**The Great Grid Upgrade**

Norwich to Tilbury

# Environmental Implications of Change – Suffolk 1

AENC-ARC-CNS-REP-0002

**Image 1: Proposed Change**

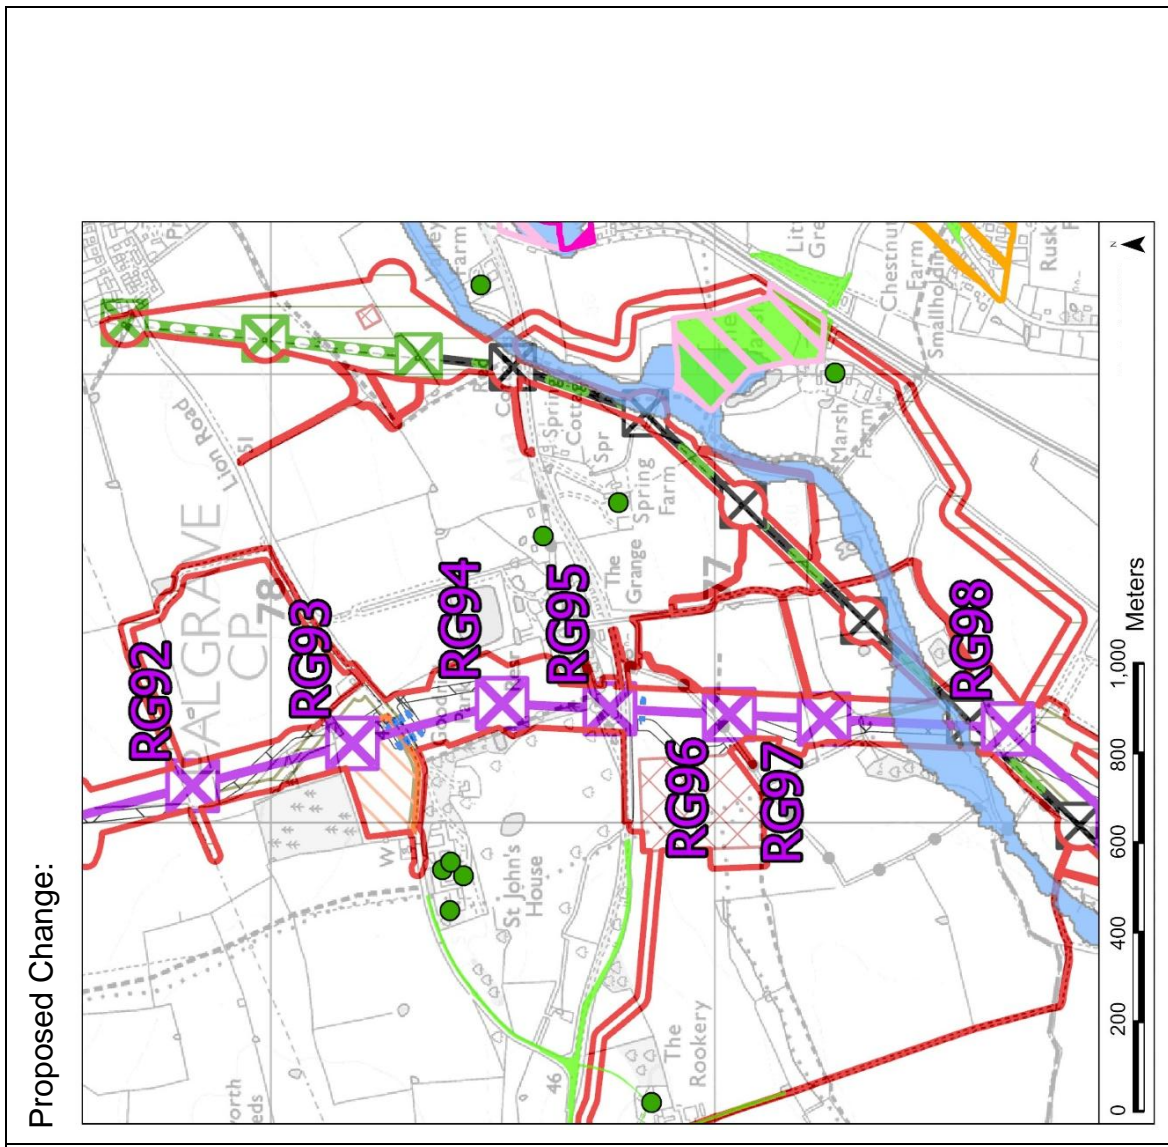
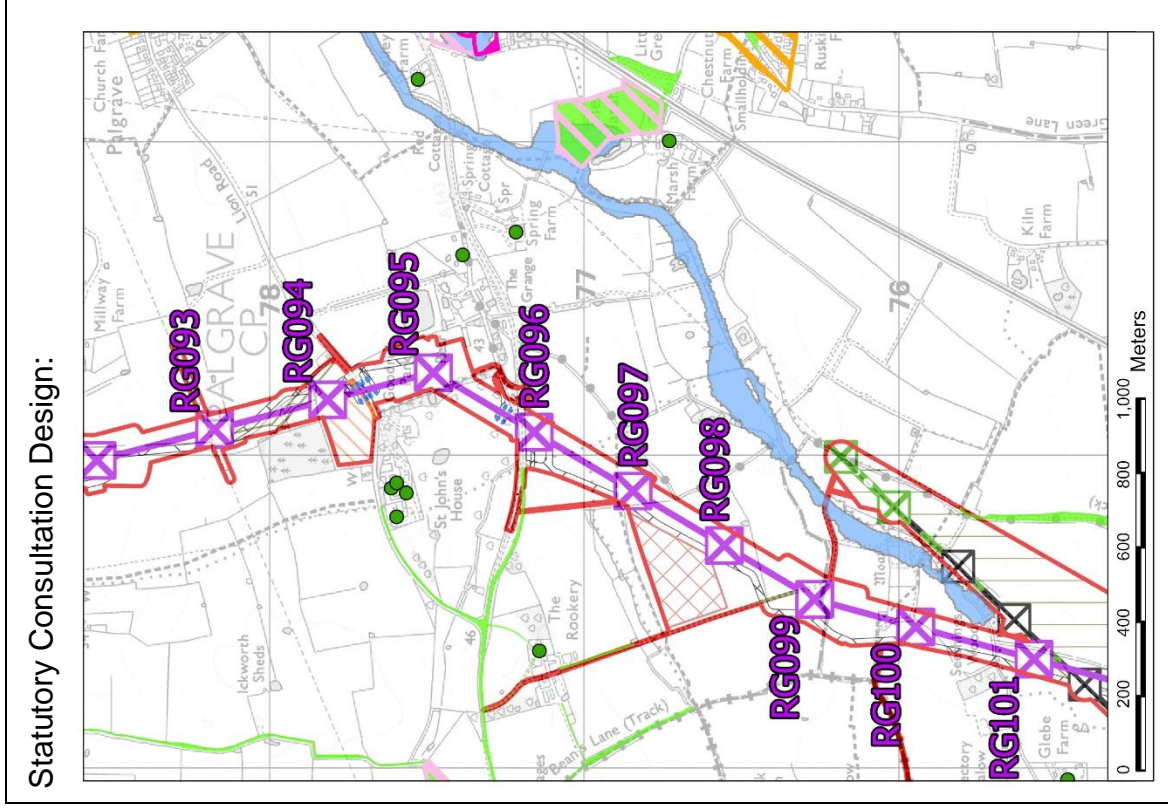
- 1.1.1 This Environmental Implications of Change document should be read alongside the associated Suffolk 1 targeted consultation leaflet. This Environmental Implications of Change document can also be viewed on the Project website.
- 1.1.2 Image 1 presents the Statutory Consultation design and the proposed change together with key environmental constraints using the key below.

<b>Environmental Topic</b>	<b>Comments / observations / identified environmental implications of the proposed change when compared to the preliminary assessment presented in the PEIR</b>
Agriculture and Soils	The proposed change would increase the length of underground cabling within Provisional Agricultural Land Classification Grade 2 and 3 land, increasing the potential of best and most versatile land being affected during construction. However, there would be no change to the type or significance of agriculture and soil effects as a result of the proposed change, when compared to the design and PEIR presented at statutory consultation.
Air Quality	There would be no change to the type or significance of air quality effects as a result of the proposed change, when compared to the design and PEIR presented at statutory consultation.
Ecology and Biodiversity	<p>The proposed change increases the amount of underground cabling. While the majority of the proposed additional underground cabling goes through arable land, the alignment does pass through Thrandeston Marsh Local Wildlife Site designated for its wet grassland habitat. This would require additional mitigation measures to reduce any likely effects.</p> <p>The proposed change crosses additional well-defined field boundaries with mature planting bands (including hedgerows and woodland bands) therefore would have a greater effect on these features (which are not designated features).</p>

<b>Environmental Topic</b>	<b>Comments / observations / identified environmental implications of the proposed change when compared to the preliminary assessment presented in the PEIR</b>
	However, with appropriate mitigation measures, there would be no change to the type or significance of ecology and biodiversity effects as a result of the proposed change, when compared to the design and PEIR presented at statutory consultation.
Contaminated Land, Geology and Hydrogeology	There would be no change to the type or significance of contaminated land, geology and hydrogeology effects as a result of the proposed change, when compared to the design and PEIR presented at statutory consultation.
Health and Wellbeing	The proposed change would locate the alignment closer to a number of health and wellbeing receptors, including residential properties, but further from others. There would be no change to the type or significance of health and wellbeing effects as a result of the proposed change, when compared to the design and PEIR presented at statutory consultation.

Historic Environment	<p>The proposed change would reduce over sail to the non-designated park associated with St Johns/Park House Grade II listed buildings.</p> <p>The proposed change to the alignment would be closer to Thrandeston conservation area and listed buildings located in the surrounding rural area. However, as the existing 132 kV alignment would be removed in this section for the 400 kV overhead line this would not lead to significant change to the settings of these assets that contribute to their values. The proposed change would also be further from a few listed buildings in the rural landscape to the west. Therefore, the proposed change would have no significant impact on the historic environment when compared to the design presented at statutory consultation.</p> <p>The proposed change would move the alignment to be adjacent to a non-designated moated site, however, the design presented at statutory consultation slightly over sailed this moated site on its western side and therefore the proposed change would have no significant change in effects. The proposed greater length of underground cabling for the 132 kV increases the distance over which there could be impacts to currently unknown archaeology, however, the width of the proposed works has reduced so there is no significant change in the total area of currently unknown archaeology that could be affected.</p> <p>During construction, the proposed change would locate the underground cabling works over 800 m to the east of the design presented at statutory consultation and the location of RG095. It is possible these construction works would affect the settings of Grade II listed Valley Farm House (1032791), Marsh Farm House (1032768) and the Thrandeston conservation area and its Grade I, II*, and II listed buildings on a temporary basis during construction. However, the short term and temporary nature of the works, combined with the benefit of removing the existing 132 kV overhead line in this location</p>

<b>Environmental Topic</b>	<b>Comments / observations / identified environmental implications of the proposed change when compared to the preliminary assessment presented in the PEIR</b>
	<p>means that overall, the proposed change is not expected to significantly alter the historic environment effects.</p> <p>Overall, there would be no change to the type or significance of historic environment effects as a result of the proposed change, when compared to the design and PEIR presented at statutory consultation.</p>
Hydrology, Land Drainage and Flood Risk	<p>There would be no change to the type or significance of hydrology, land drainage and flood risk effects as a result of the proposed change, when compared to the design and PEIR presented at statutory consultation.</p>
Landscape and Visual	<p>The proposed change to the alignment would cross part of a shallow valley with smaller-scale fields and well-defined field boundaries with mature vegetation (including hedgerows and trees). This is a more intimate, well-vegetated and sparsely populated landscape than the design presented at statutory consultation, which passes through lightly rolling arable fields. The proposed change to the alignment would move the overhead line away from the grounds of Goodrich Park / St John's House, a recreational venue used for events and camping, with a cluster of listed buildings. However, it is likely that the proposed change would be closer than the design presented at statutory consultation to visual receptors at The Grange in the north near RG095.</p> <p>There would likely be landscape and visual benefits due to the removal of the additional length of 132 kV overhead line. This would reduce the sense of 'encirclement' experienced by properties north and south of the A143 (eg Spring Farm, The Grange). The proposed extension to the 132 kV removal would result in a longer underground cable route that would cross additional watercourses and an area of Countryside and Rights of Way Registered Common Land at Thrandeston Marsh. The proposed change would bring the underground cable alignment closer to properties including Marsh Farm, although visual effects would be temporary during construction. Some mature trees within hedgerows would be affected by the underground cable alignment.</p> <p>However, overall, there would be no change to the type or significance of landscape and visual effects as a result of the proposed change, when compared to the design and PEIR presented at statutory consultation.</p>

Noise and Vibration	<p>There would be no change to the type or significance of noise and vibration effects as a result of the proposed change, when compared to the design and PEIR presented at statutory consultation.</p>
Socio-economics, Recreation and Tourism	<p>The proposed change would temporarily affect Little Green Wedding Barn and The Marsh (East Suffolk) with the proposed undergrounding diversion. Overall, however, there would be no change to the type or significance of socio-economic, recreation and tourism effects as a</p>

Environmental Topic	Comments / observations / identified environmental implications of the proposed change when compared to the preliminary assessment presented in the PEIR
	result of the proposed change, when compared to the design and PEIR presented at statutory consultation.
Traffic and Transport	There would be no change to the type or significance of traffic and transport effects as a result of the proposed change, when compared to the design and PEIR presented at statutory consultation.

- 1.3.1 The proposed change would not materially change the conclusions that were reported within the PEIR (National Grid, 2024) which was published for statutory consultation. The PEIR can be viewed [here](#).
- 1.3.2 If the proposed change is taken forwards, the baseline information (and environmental surveys) and assessment associated with this change would be provided in the Environmental Statement (ES).
